MODEL MD900 SERIES
SERVICE LETTER PACKAGE

MODEL MD900[®] ROTORCRAFT (MD EXPLORER[®]) SERVICE LETTERS

Figure 2. Window, Doubler, Gasket, Fabrication and Layout

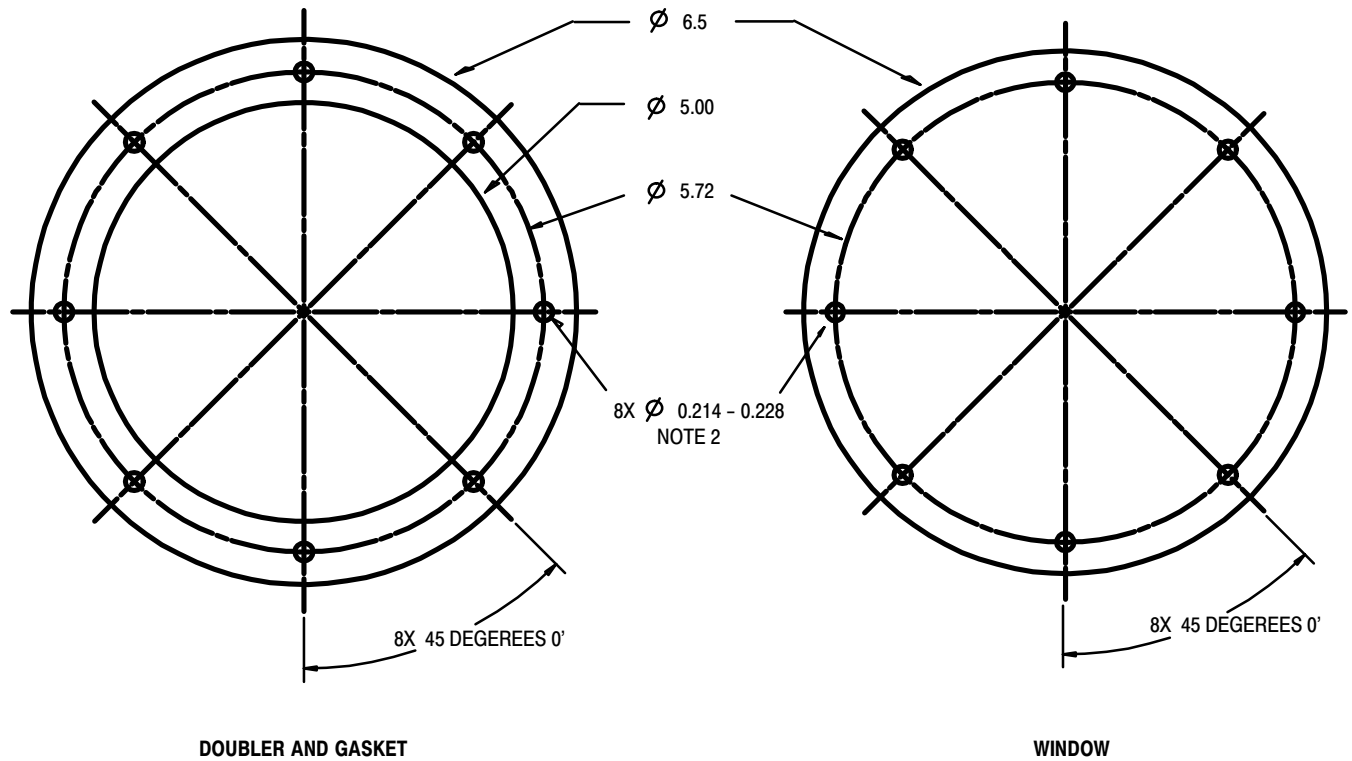
- NOTE 1: ALL DIMENSIONS ARE IN INCHES
NOTE 2: USE EXISTING VENT AS TEMPLATE TO HELP DRILL HOLES
NOTE 3: DOUBLER MATERIAL; AL-ALY SH ALCD, 2024-T3, 0.040 INCH THK, QQ-A-250/5 OR EQUIVALENT
NOTE 4: GASKET MATERIAL; SILICONE SHEET, CL 2B GR 50 BLK, 0.031 INCH THK, ZZ-R-765 OR EQUIVALENT
NOTE 5: WINDOW MATERIAL; CLEAR POLYCARBONATE PLASTIC SHEET, 0.090 INCH THK, AMS3611 OR EQUIVALENT

Figure 3. Cabin Door Handle Installation

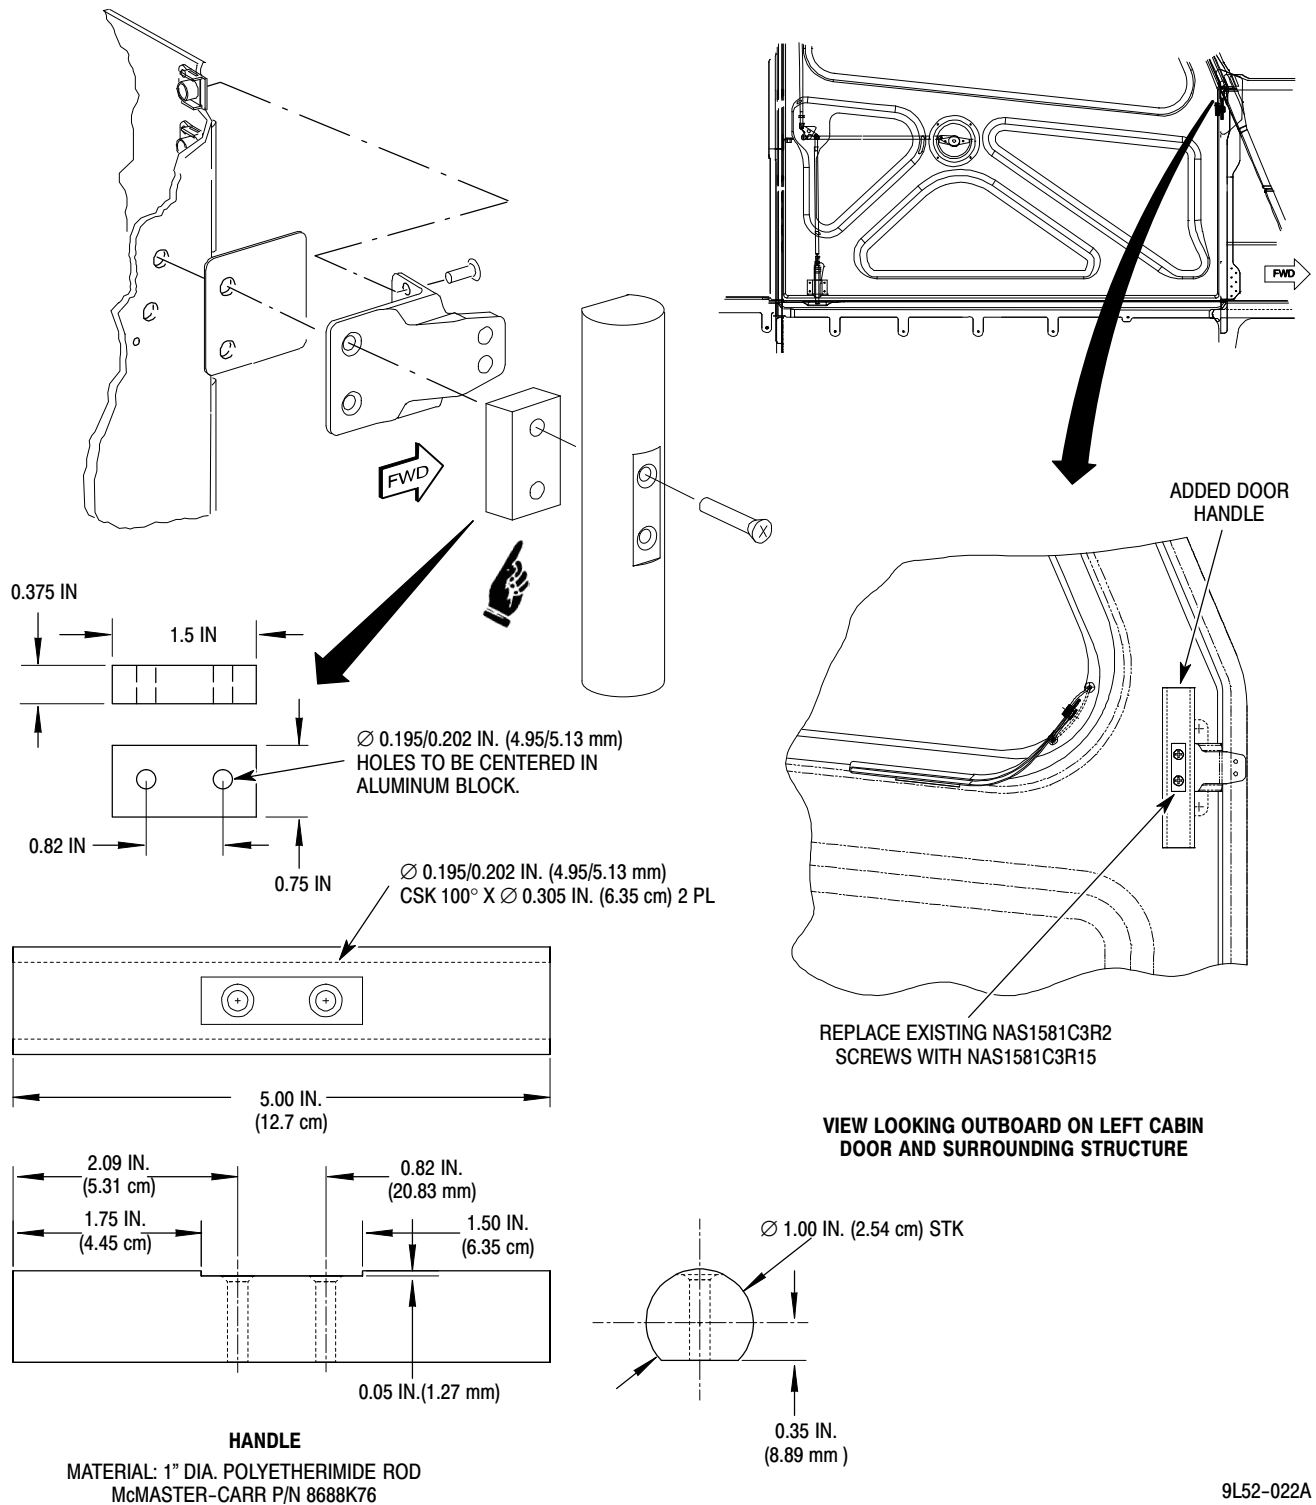
* Supersedes SL900-025 dated 08 January 1997. Reason for Revision: To allow installation of a spacer under the door handle to provide the handle better clearance from adjacent structure.

At the discretion of Boeing MD900 owners/operators, a cabin door handle may be installed to aid in closing the cabin door. Instructions in this Letter provide customers with details to fabricate a spacer, handle and install the handle and spacer to the cabin door.

- (1). Fabricate handle per Figure 1, deburr holes and radius all edges.
- (2). Fabricate aluminum spacer as shown in Figure 1.
- (3). Remove screws from cabin door fitting indicated in Figure 1 and discard.
- (4). Install and tighten replacement screws, handle and spacer into screw holes of cabin door fitting indicated in Figure 1.

Figure 1. Crosstube Fairing Modification (Typical LH and RH)

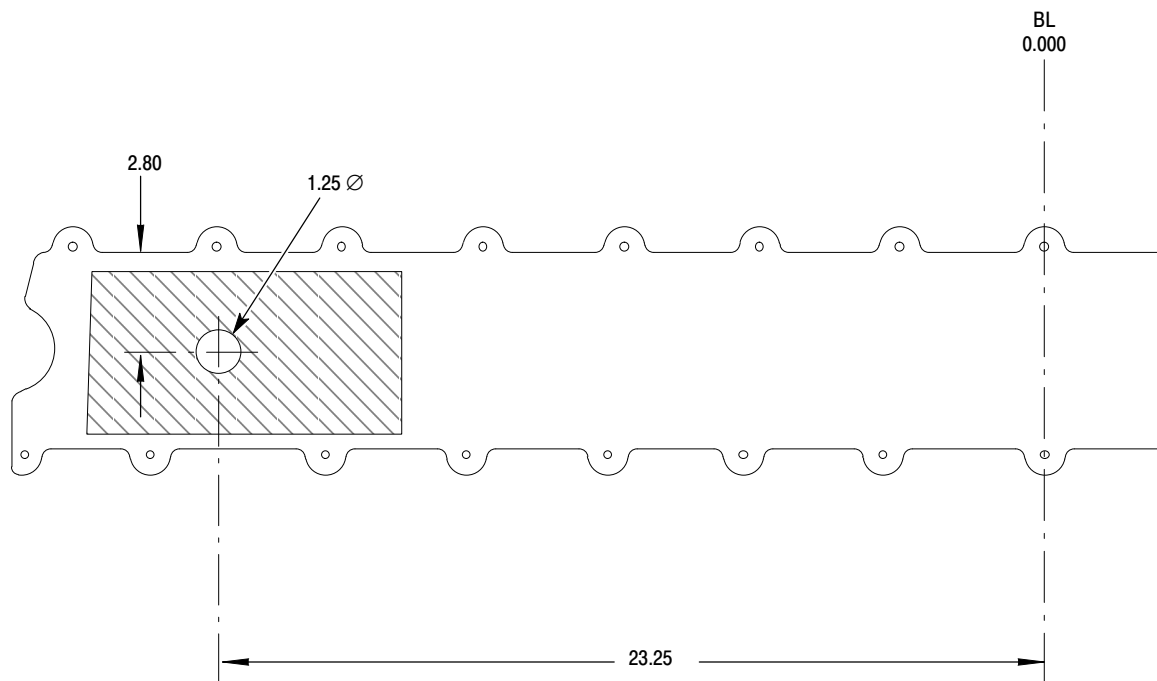
A. Remove aft landing gear fairing (Ref. CSP-900RMM-2, Section 06-00-00).

Hole location is not accurate for all aircraft. Check dimension on aircraft from BL 0.000 screw hole to insert in landing gear saddle fitting.

- 2). Deburr holes and touch up with chem film and primer.

Figure 1. Anti-Torque Fan Inlet Screen

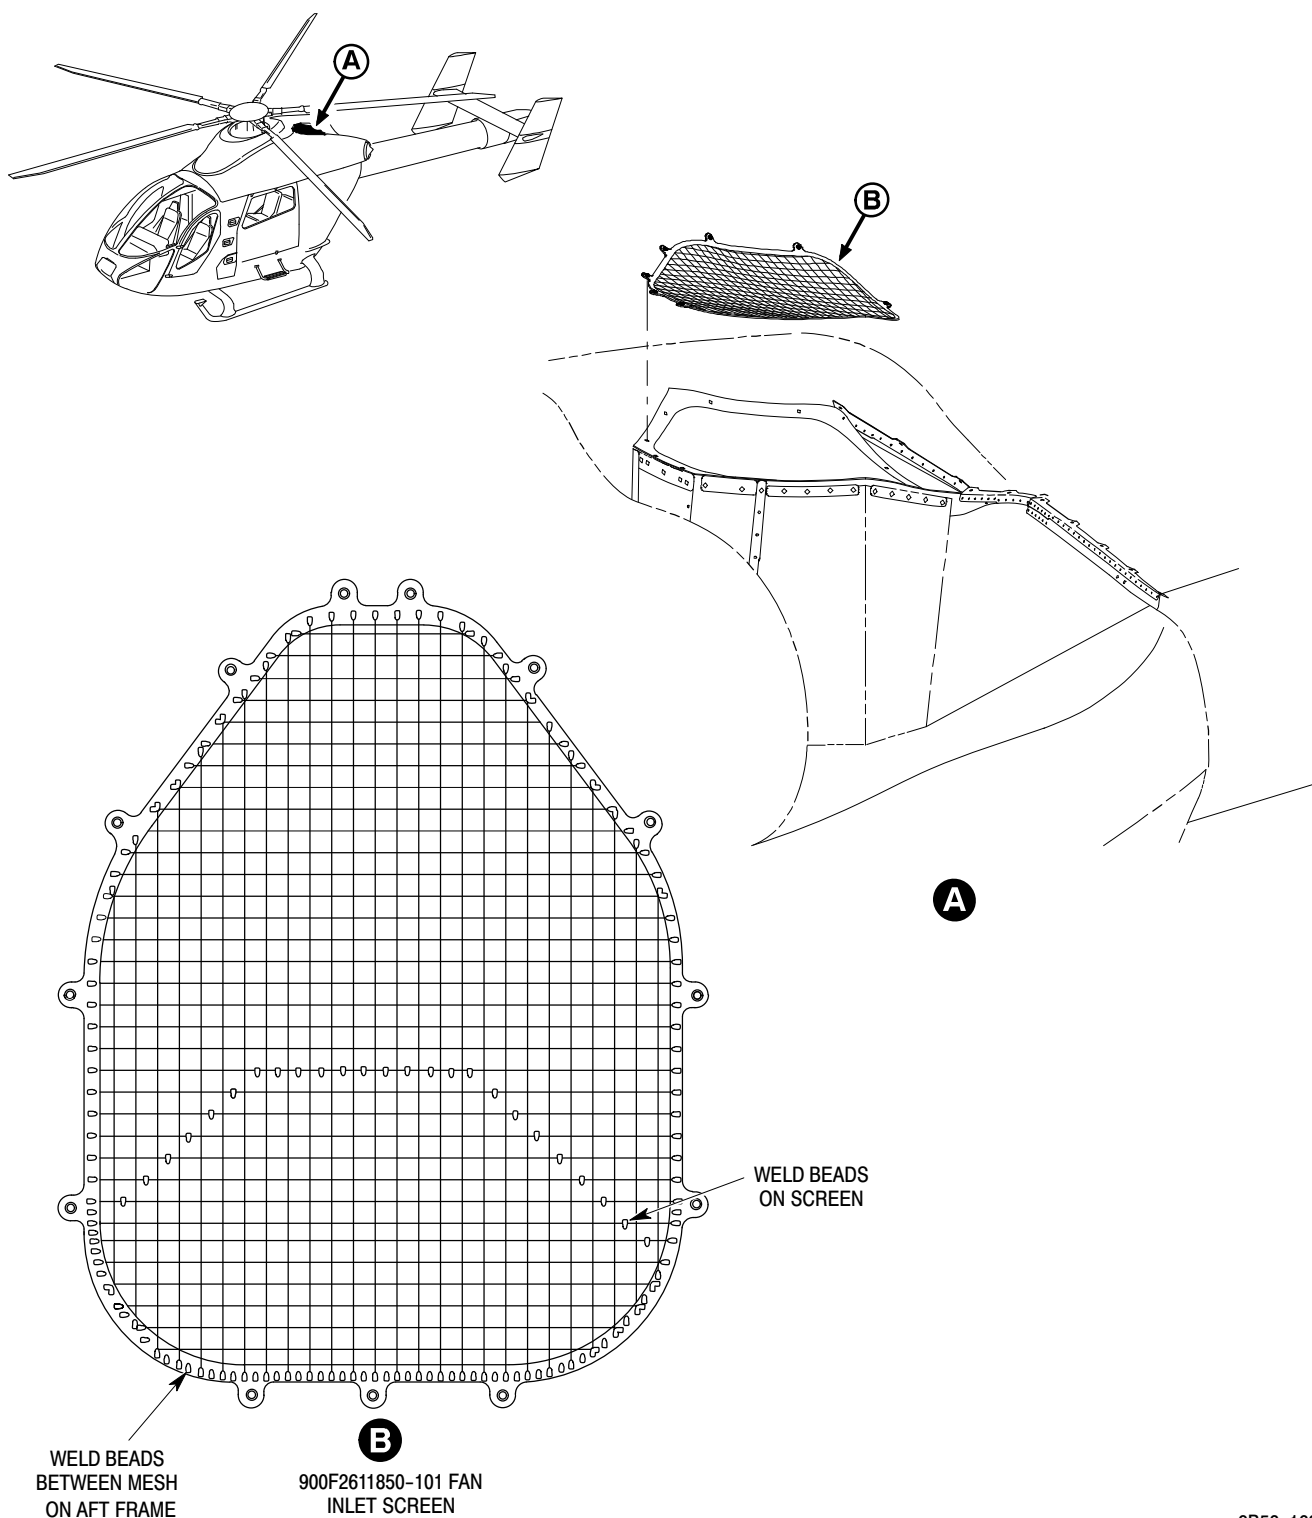
This Service Letter is issued to advise all owners and operators of possible cracks occurring in certain P/N 900F2611850-101 anti-torque fan inlet screens. These screens can be identified by weld beads between the mesh on the aft screen frame and weld beads on the screen itself (Ref. Figure 1).

Figure 1. Anti-Torque Control Pedal Installation

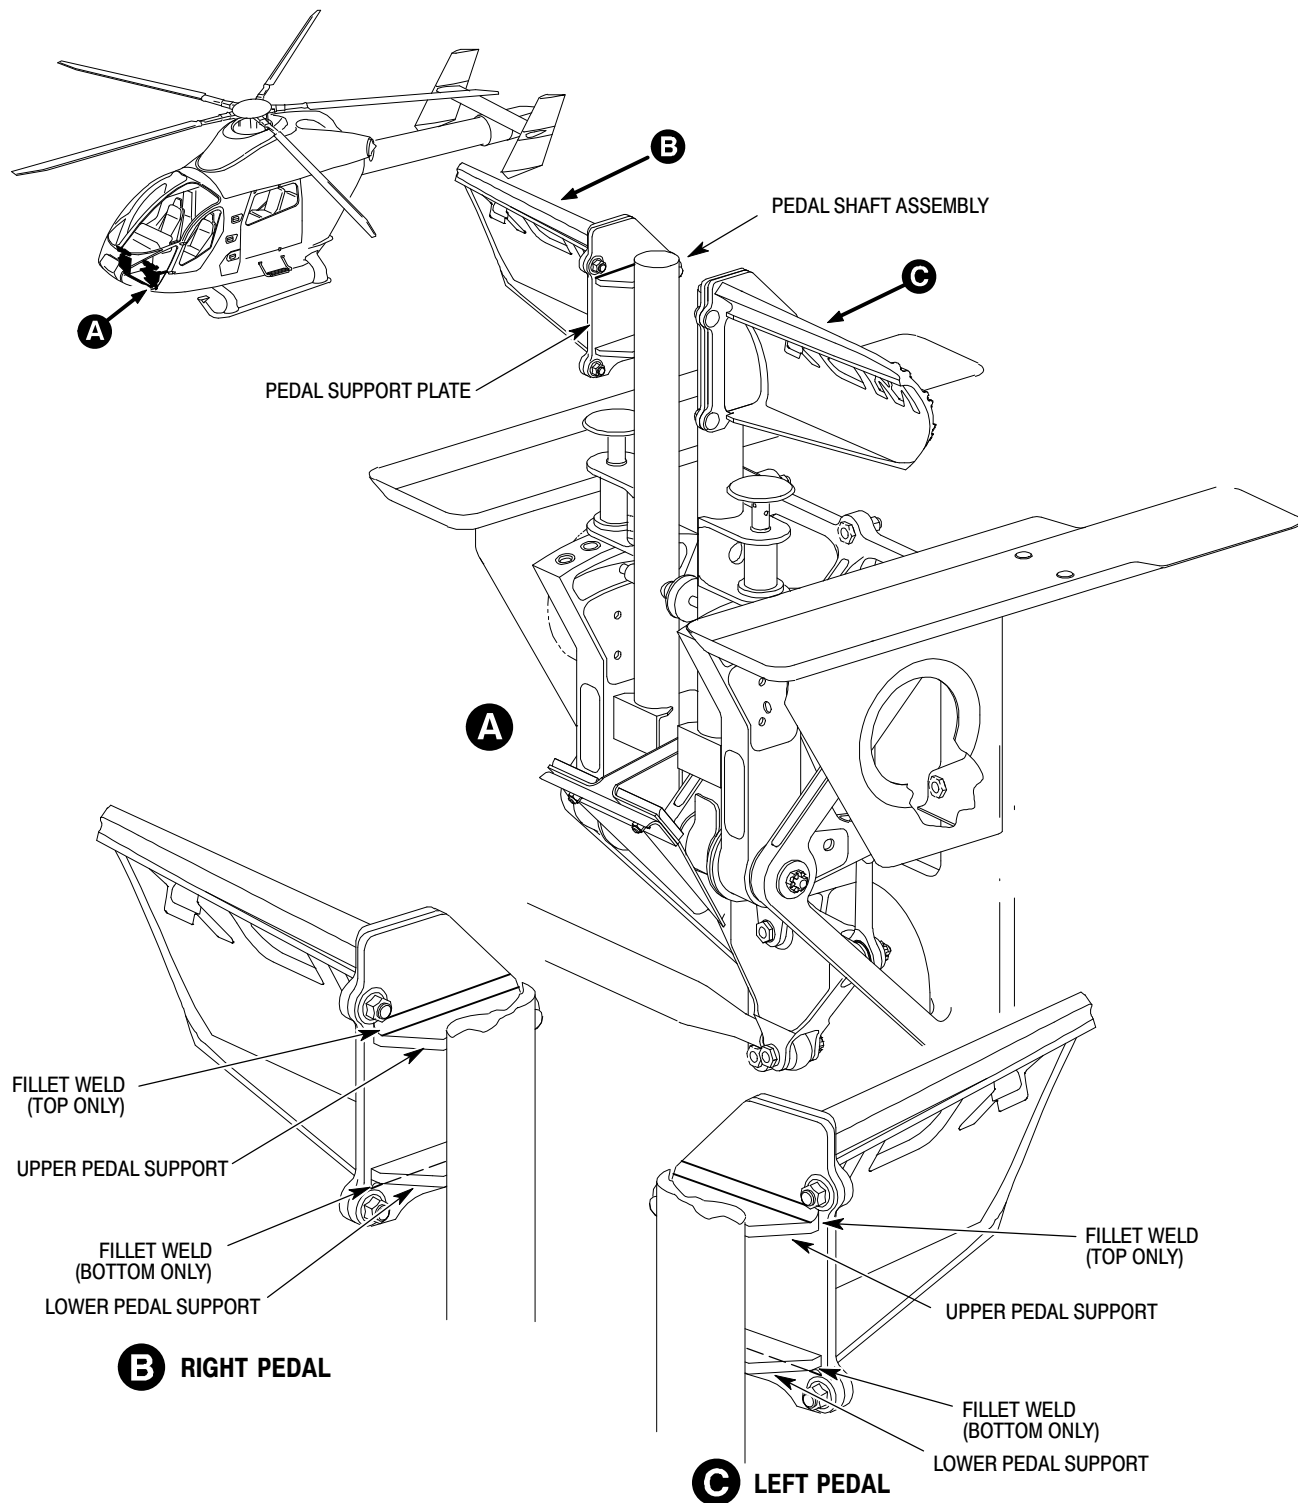
This Service Information Letter is issued to inform owners and operators of MD900 helicopters of an accident where an anti-torque control pedal separated from the pedal shaft assembly. This incident is under investigation. A possible cause may be poor penetration on the fillet weld on the pedal support plate and fatigue (Ref. Figure 1).

If a pedal should separate from the shaft, anti-torque control can be maintained by the pilot placing his foot on the pedal shaft to maintain directional control. If this occurs in flight, perform a normal landing as soon as possible.

Figure 1. Main Rotor Blade Retention Bolt

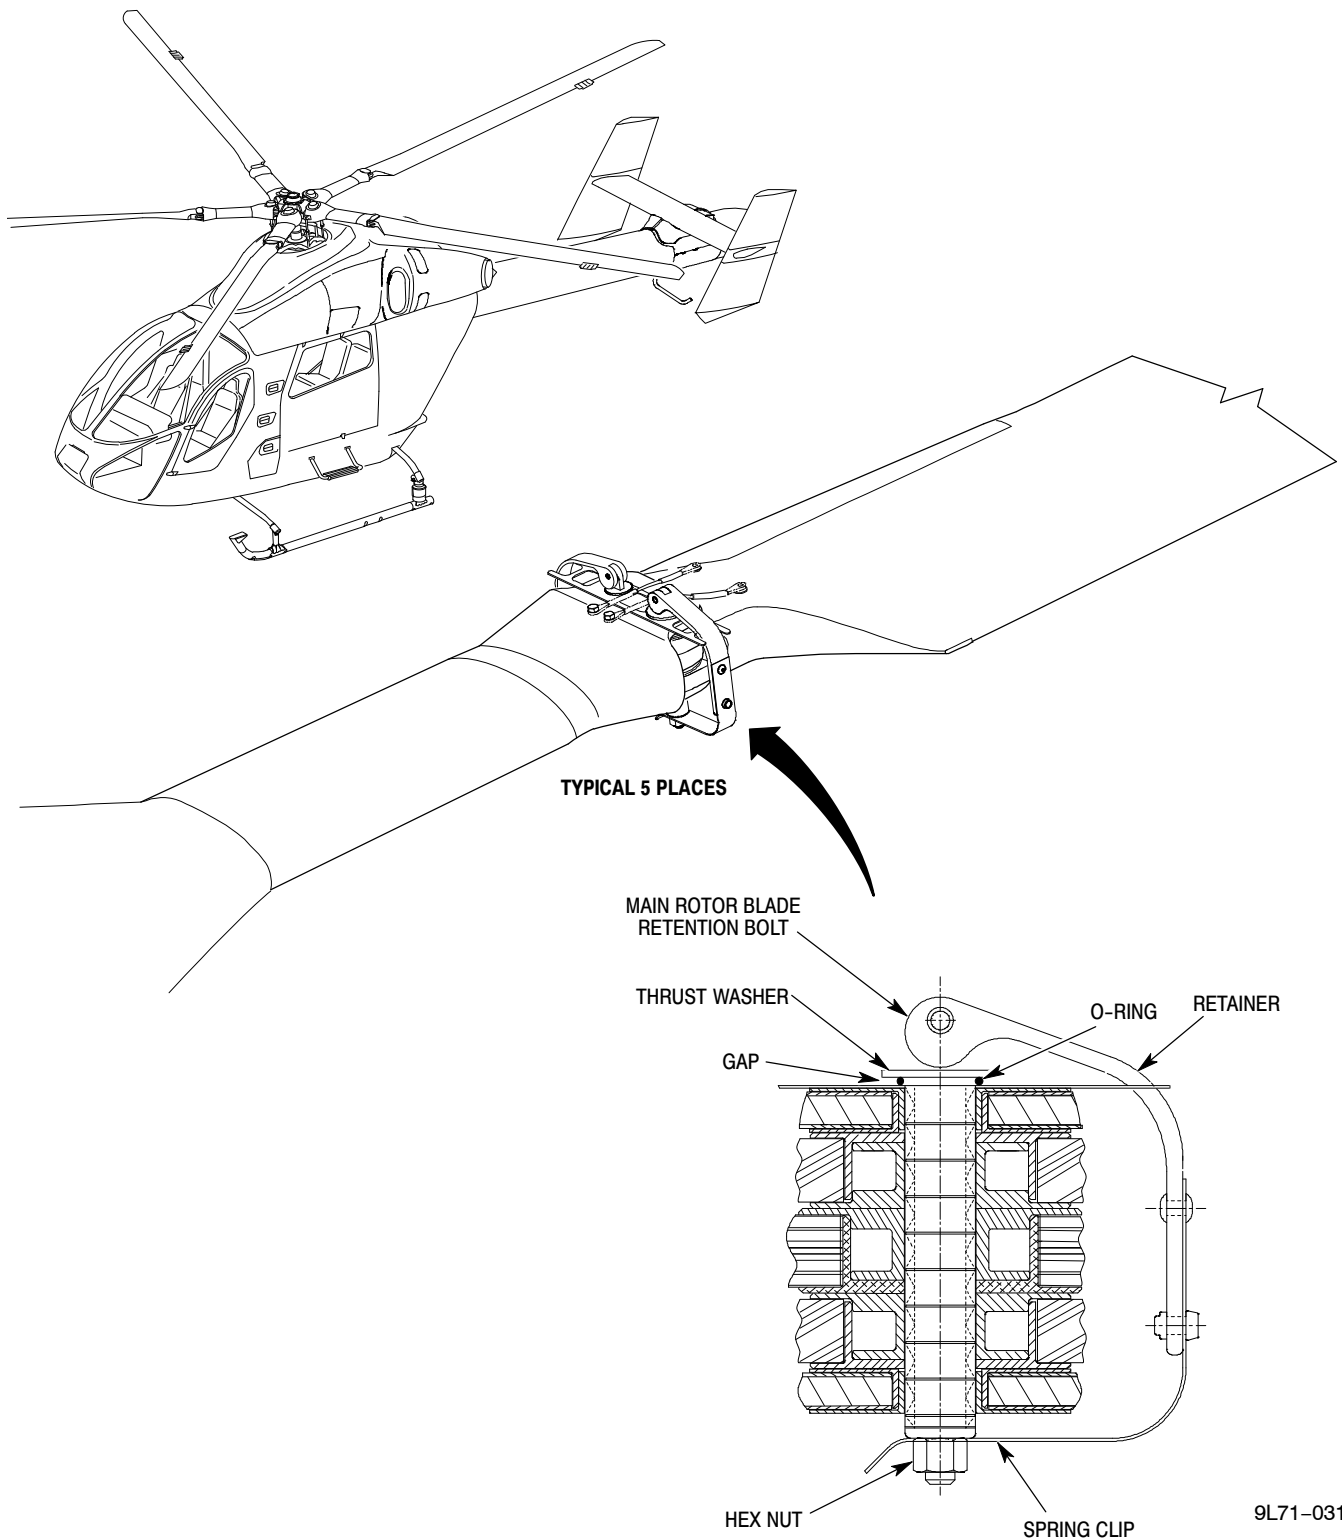
This Service Letter is issued to recommend that operators do a visual check of the main rotor blade retention bolt before or after each flight. An operator with at least a private pilot certificate can do the visual check.

Visually examine the area around the hex hole in the spring clip for cracks. Make sure spring clip hex hole is fully engaged on hex nut. Visually examine the position of each main rotor blade retention bolt to make sure it has not moved up in the pitchcase. Make sure there is a gap between the main rotor blade retention bolt thrust washer and the retainer. Compare the gap between the main rotor blade retention bolt thrust washer and retainer to the gap at the other nine bolts. Each of the ten gaps must be almost the same.

If you think a main rotor blade retention bolt has cracks around the spring clip hex hole, spring clip hex hole is not fully engaged on hex nut, has moved up, or there is no gap under the thrust washer, have a certificated maintenance technician remove bolt and do a detailed inspection of the bolt (Ref. CSP-900RMM-2, Section 62-10-00). If no defects are found, install bolt (Ref. CSP-900RMM-2, Section 62-10-00).
